ATTACHMENT 3 TO TXX-94045

AFFECTED TECHNICAL SPECIFICATION PAGES  
(NUREG-1468) REVISED BY ALL APPROVED  
LICENSE AMENDMENTS

FIGURE 5.1-3

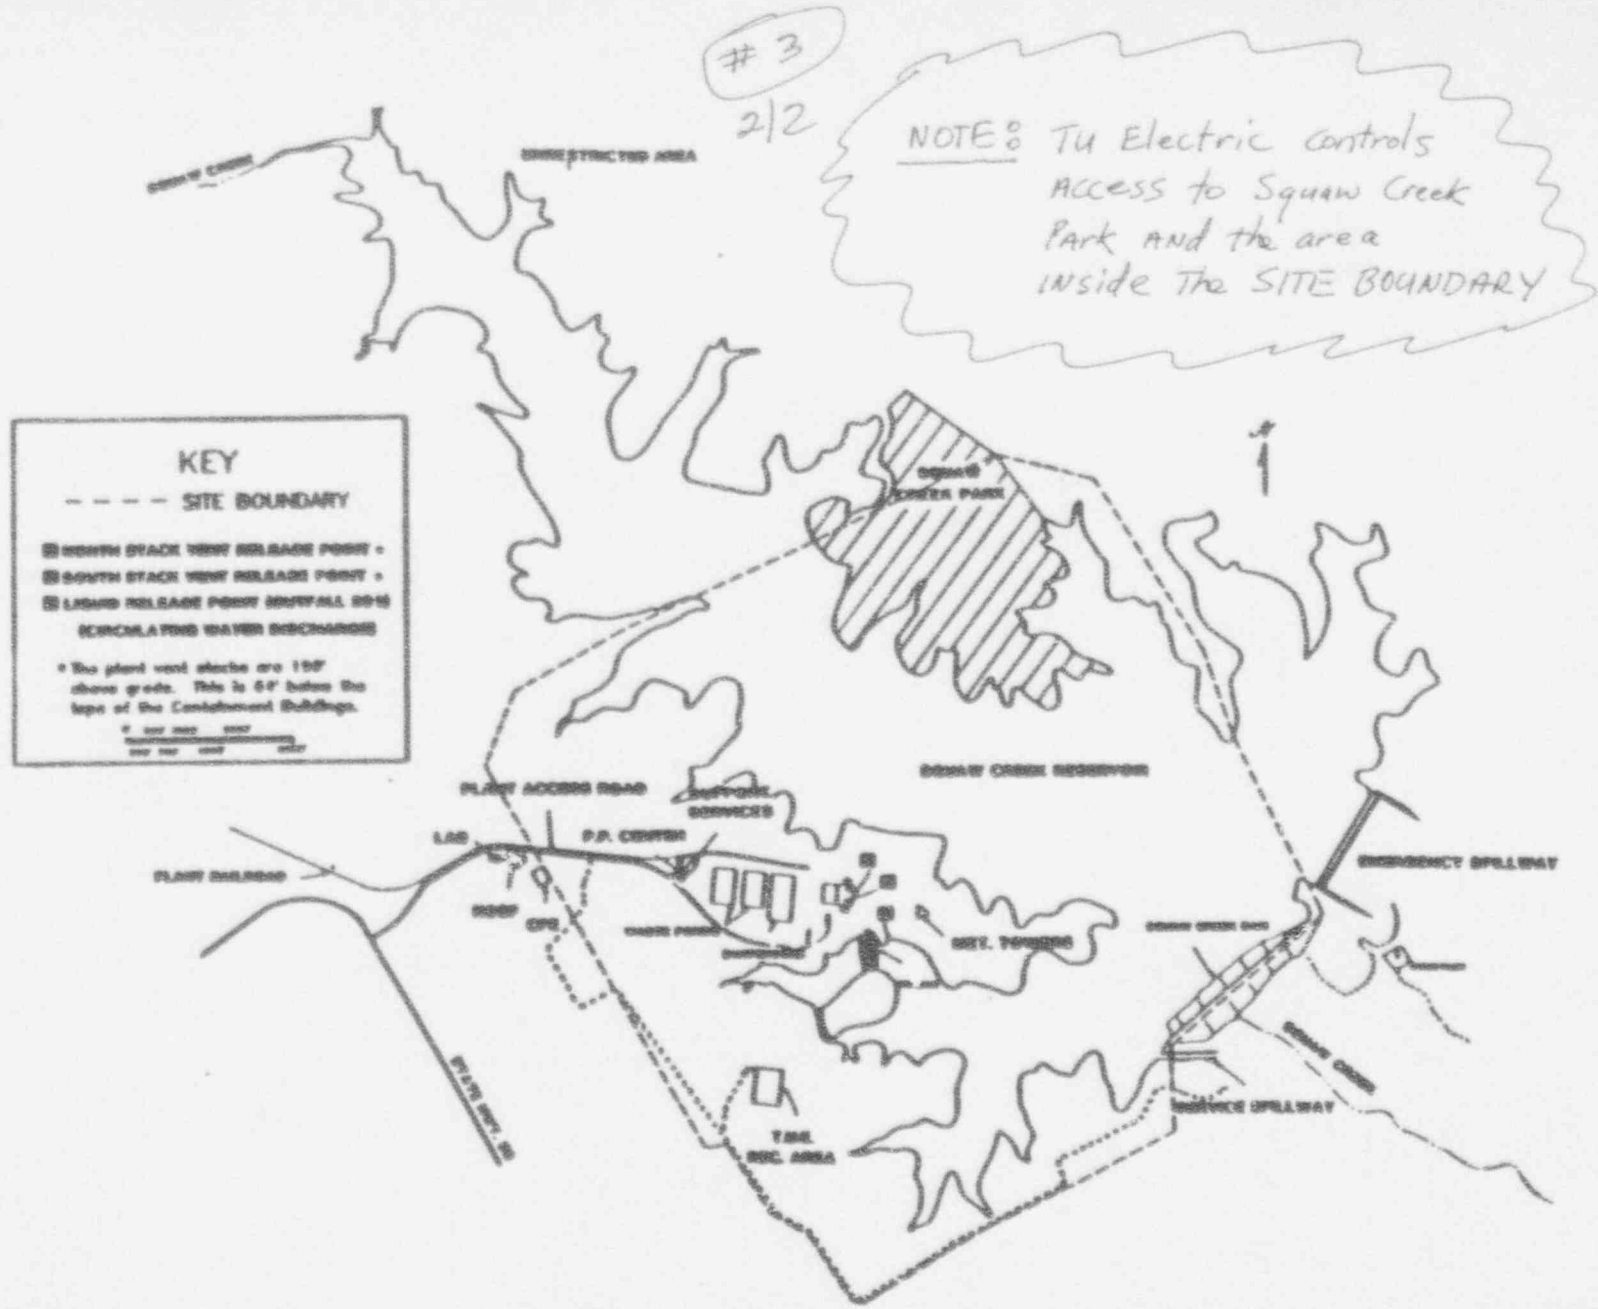
5.1.3 Information regarding radioactive gaseous and liquid effluents, which will allow identification of structures and release points as well as definition of UNRESTRICTED AREAS within the SITE BOUNDARY that are accessible to MEMBERS OF THE PUBLIC, shall be as shown in Figure 5.1-3.

The definition of UNRESTRICTED AREA used in implementing these Technical Specifications has been expanded over that in 10 CFR ~~20.3(a)(17)~~ <sup>20.1003</sup>. The UNRESTRICTED AREA boundary may coincide with the Exclusion Area Boundary, as defined in 10 CFR 100.3(a), but the UNRESTRICTED AREA does not include areas over water bodies. The concept of UNRESTRICTED AREAS, established at or beyond the SITE BOUNDARY, is utilized in the Limiting Conditions for Operation to keep levels of radioactive materials in liquid and gaseous effluents as low as is reasonably achievable, pursuant to 10 CFR 50.36a.

#3  
1/2
